Version C Villa Door Stations Release Note

(2025-09-10)

Firmware Basic Information	Firmware Version	V3.7.0_build250905
	Device Model	DS-KV8X13-WME1(C) DS-KV6113-WPE1(C), DS-KV6113-PE1(C), DS-KV6103-PE1(C) DS-KV6133-ME1, DS-KV6133-WME1 DS-KIS603-P(C), DS-KIS604-P(C), DS-KIS604-S(C)

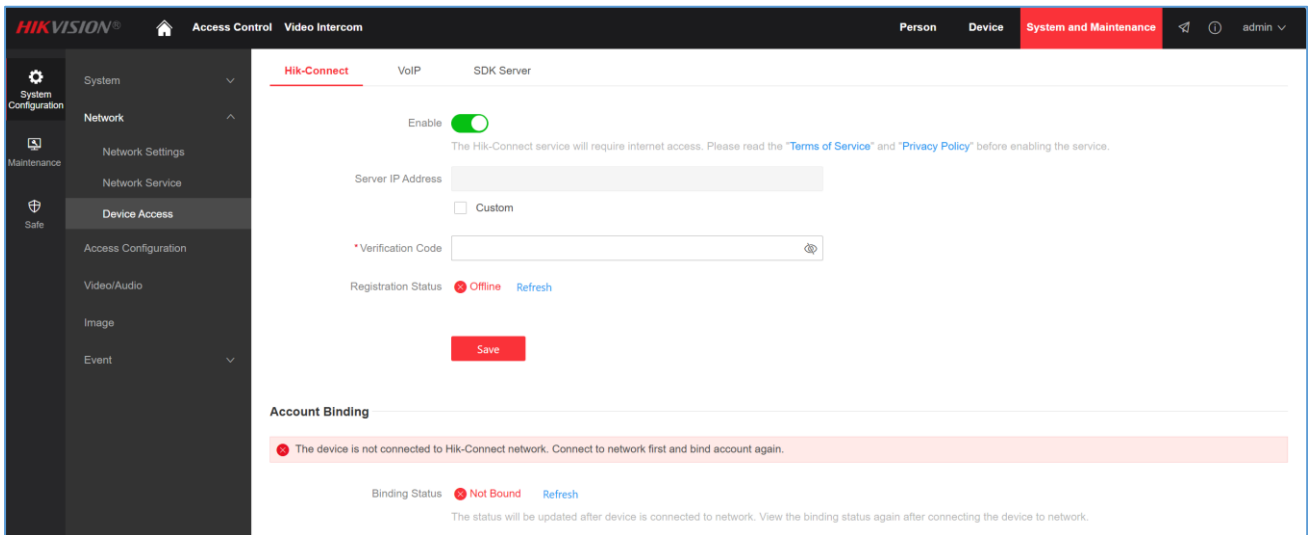
1. Update to new webpage UI

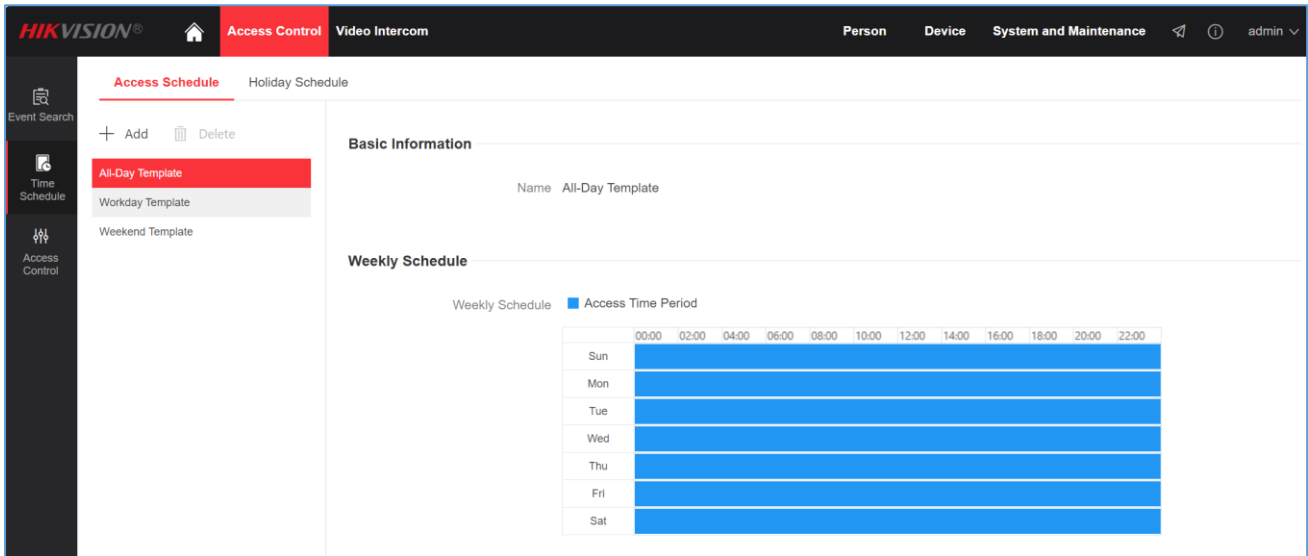
2. Support Hik-Connect function, add device to and manage in Hik-Connect and Hik-Partner Pro app.

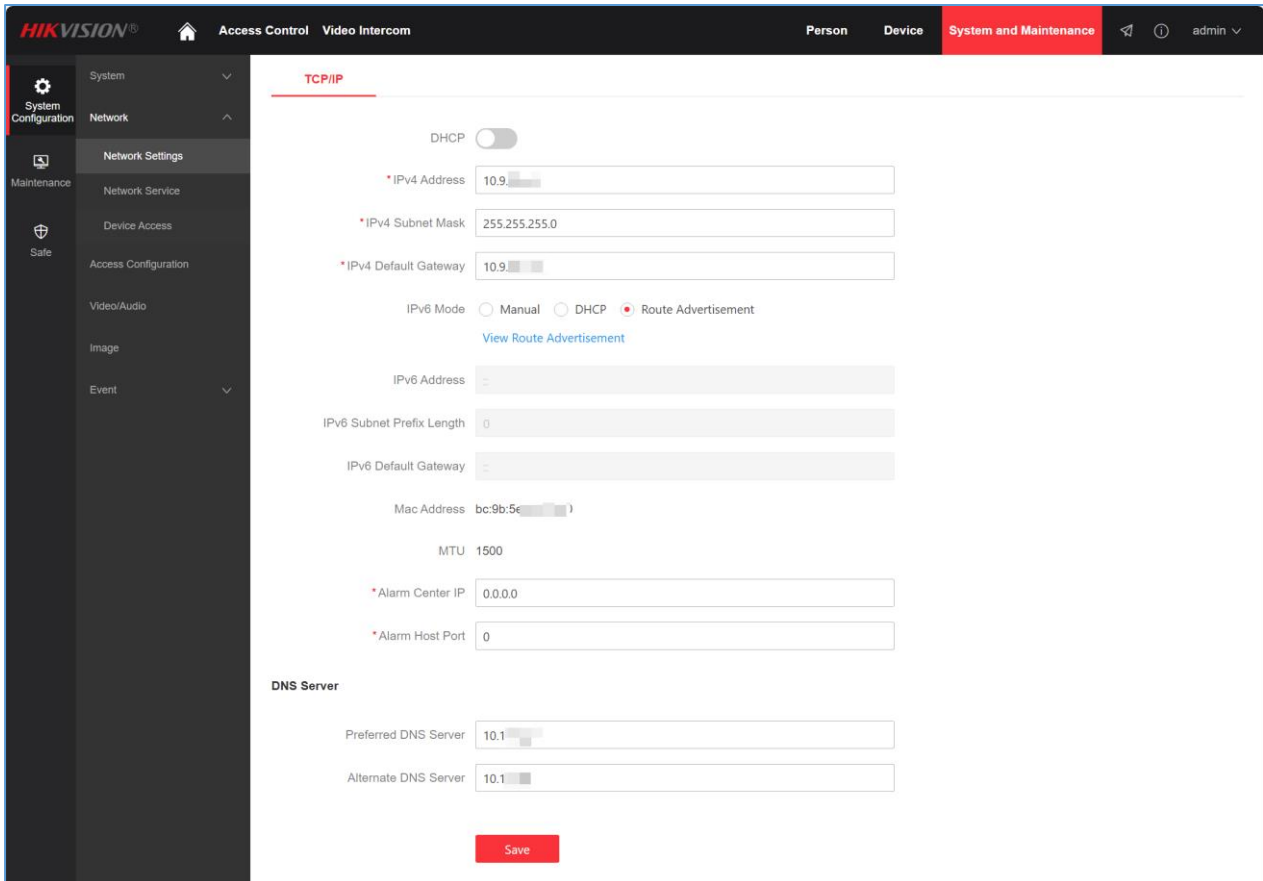
3. Support Access Schedule and the verification will only work during the valid time period.

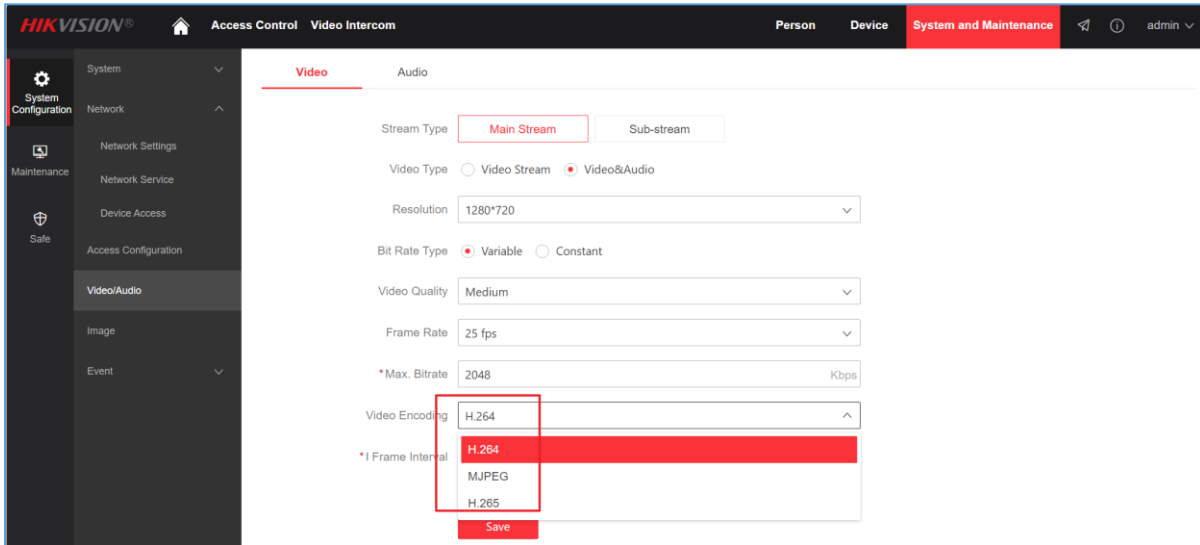
4. Support IPv6 network

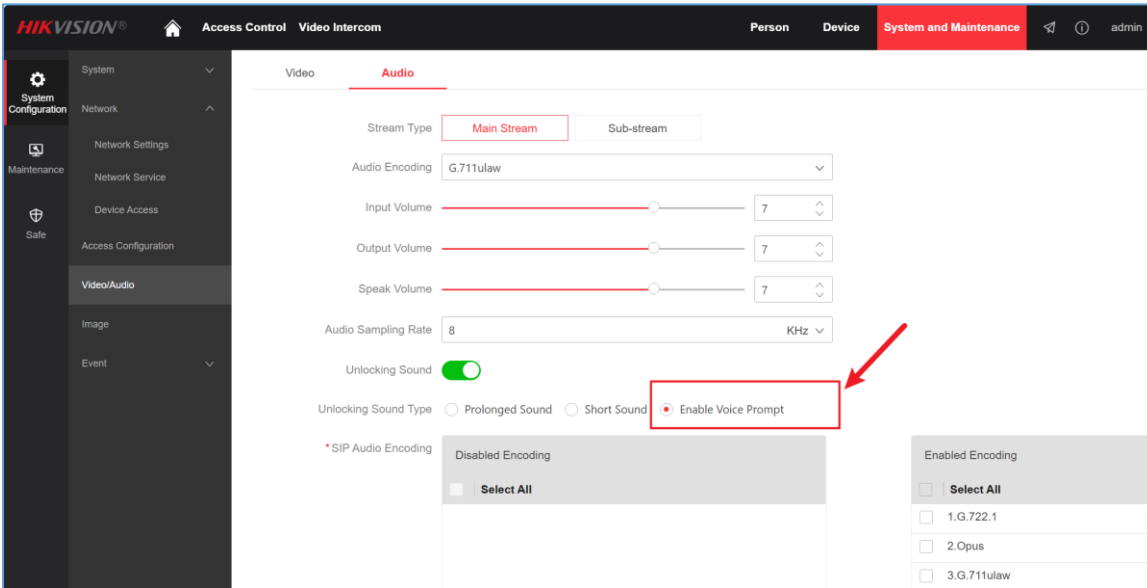
1. Add voice prompt “The door is open” back. Now we have 4 options, disable unlocking sound, short beep sound, long beep sound and voice prompt “The door is open”.

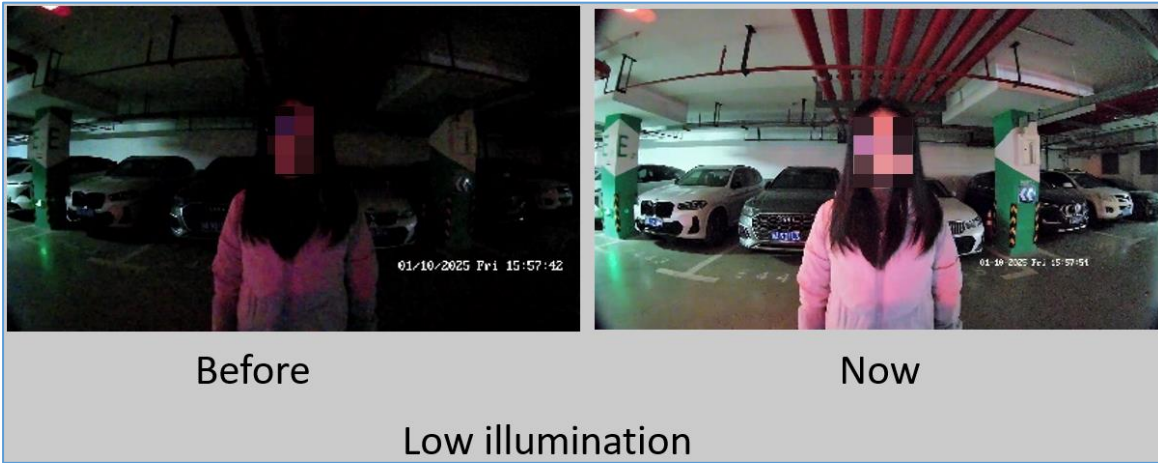
2. Video quality improvement

- 1) WDR enabled by default.
- 2) Video quality remains clear even when backlit or in low light

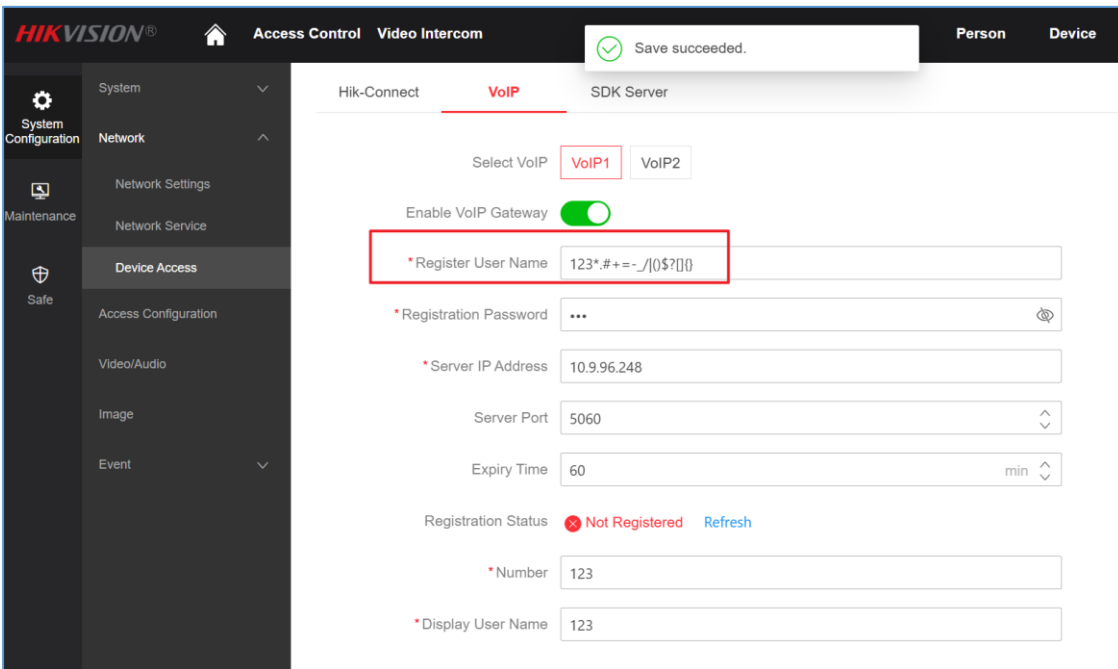
4. Support 2 sip lines and input special characters in SIP number settings, including *.#+==-_/|0\$?[]{}

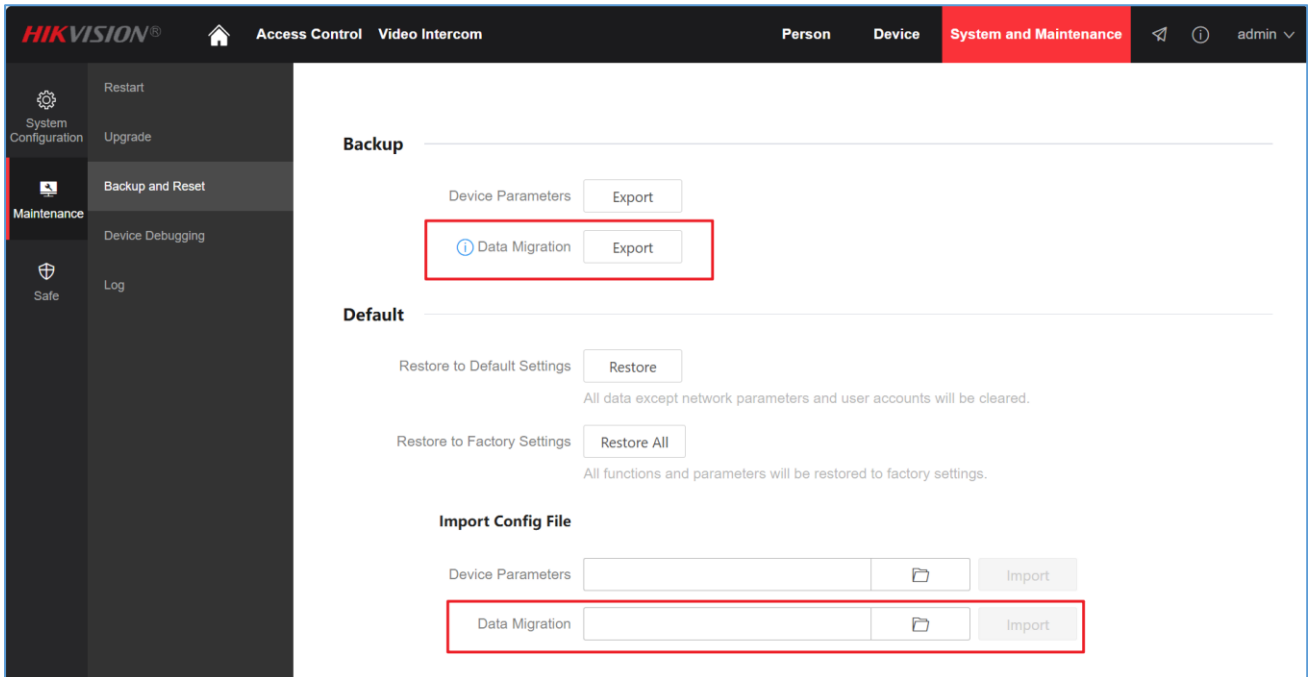
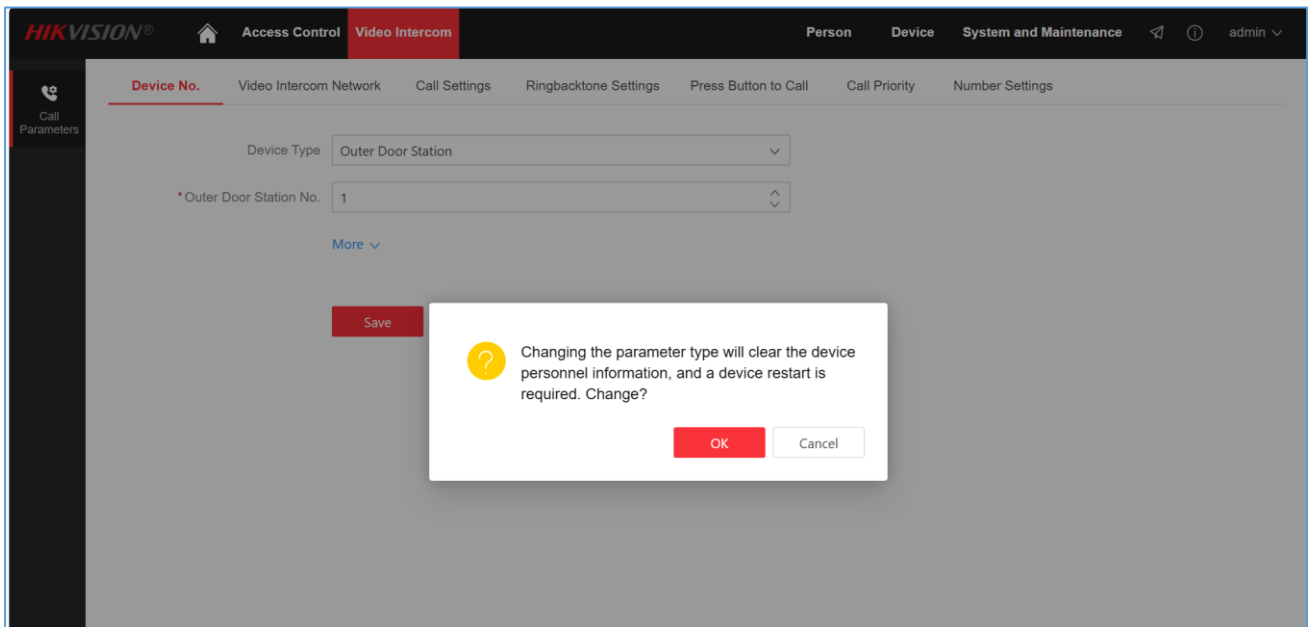
5. Support data export and import.

- a. The data exported and imported devices should share same model and firmware version in

case of any data format incompatibility.

- b. The data includes user information, door station parameters configuration data, ringtone and etc.

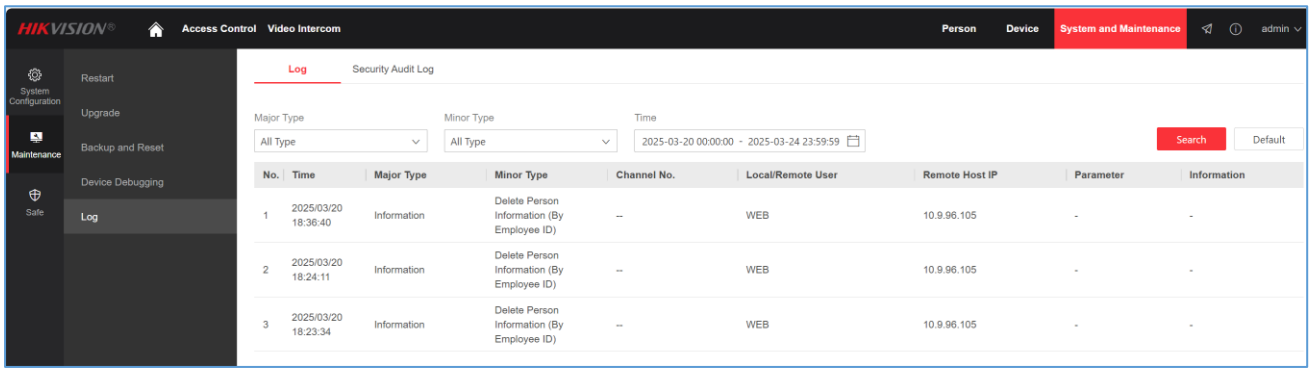
- 6. When changing the device mode between door station and outer door station, all personnel data will be deleted, please take care for the data loss, and add the prompt as below picture.

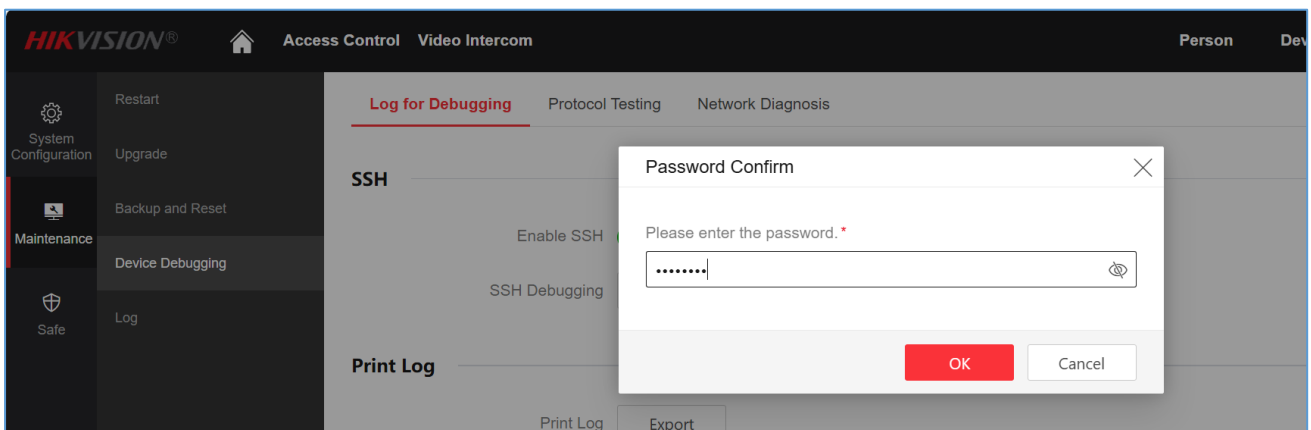
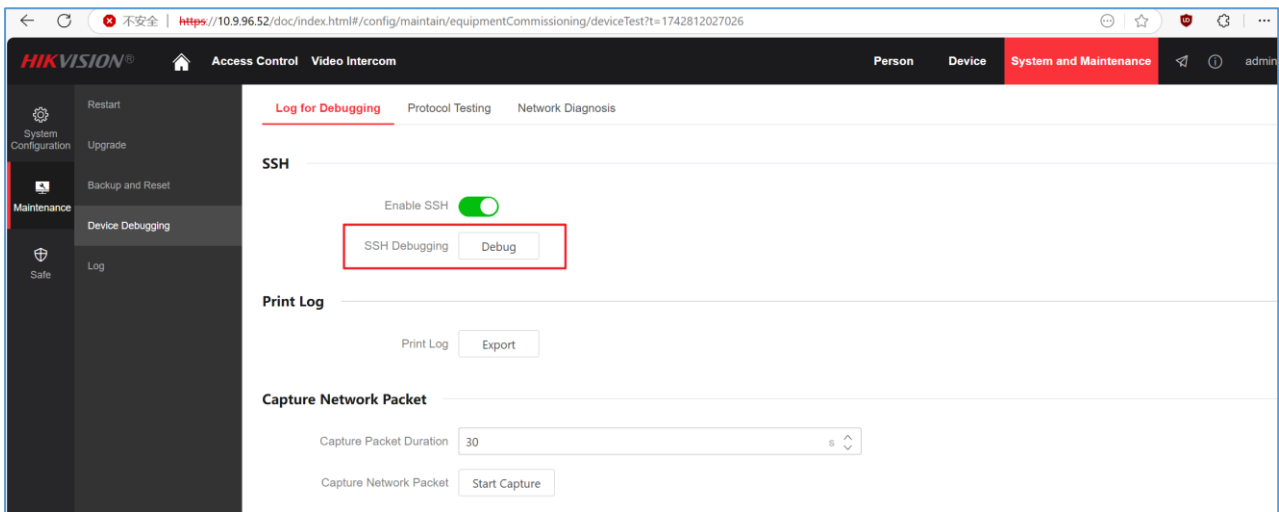
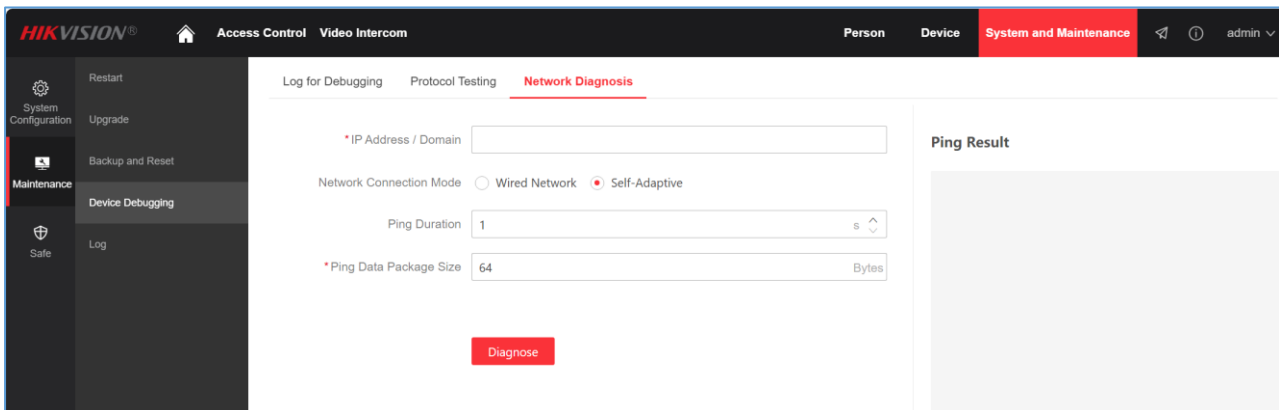
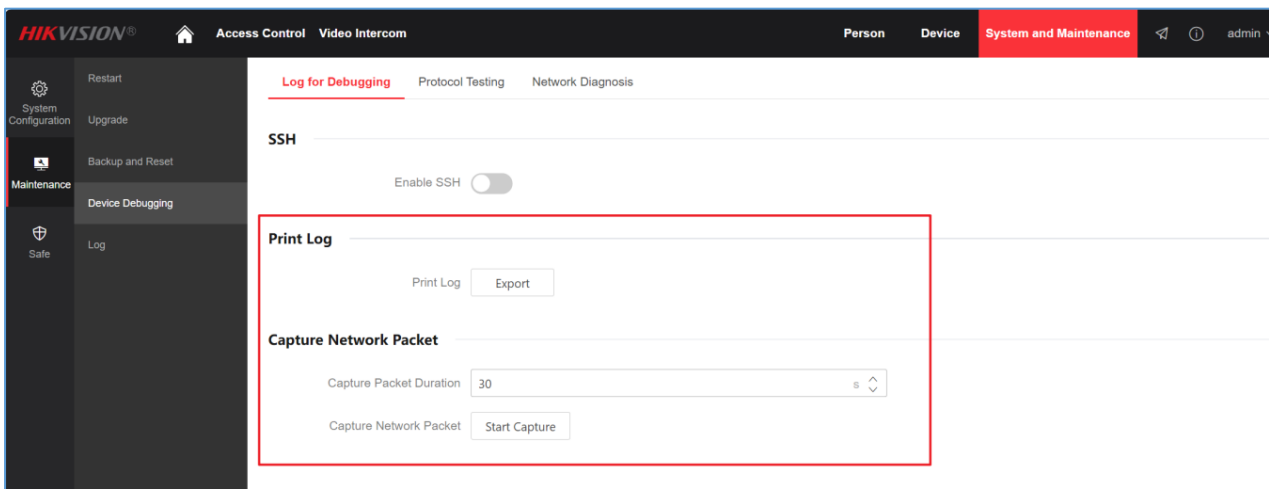
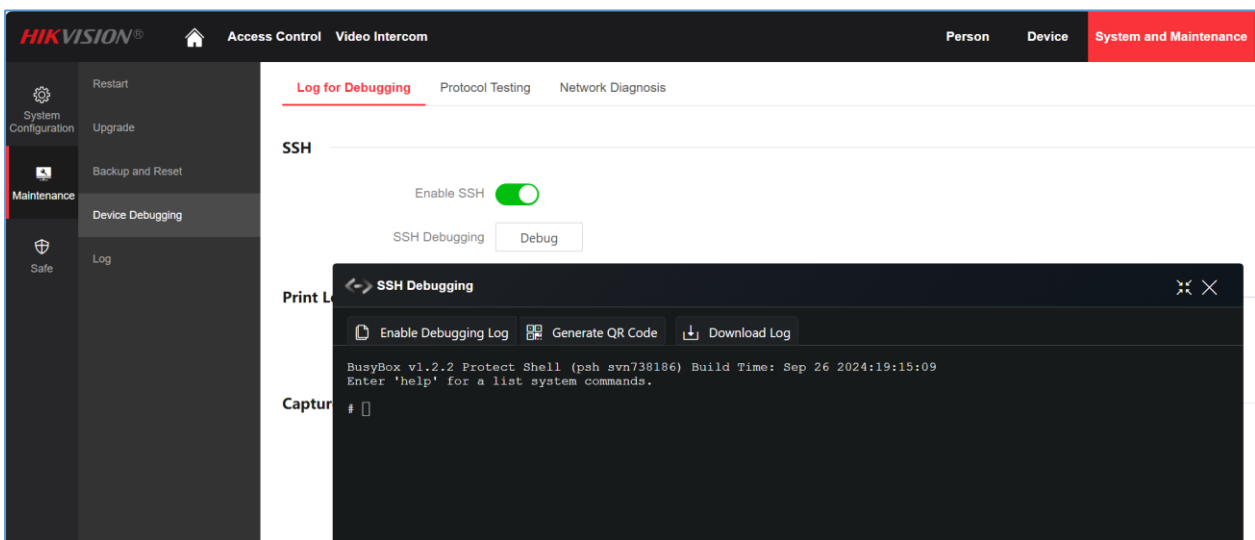
- 7. Support operation log search(max 1,000), including unlock records, call elevator records, tamper alarm, login in/out records, etc.

8. Support web SSH, key logs export, ping tools, capture network packet on the webpage for easier technical diagnose

Note: web SSH function is only available in HTTPS protocol, please login device webpage with https. For example <https://device ip address/>
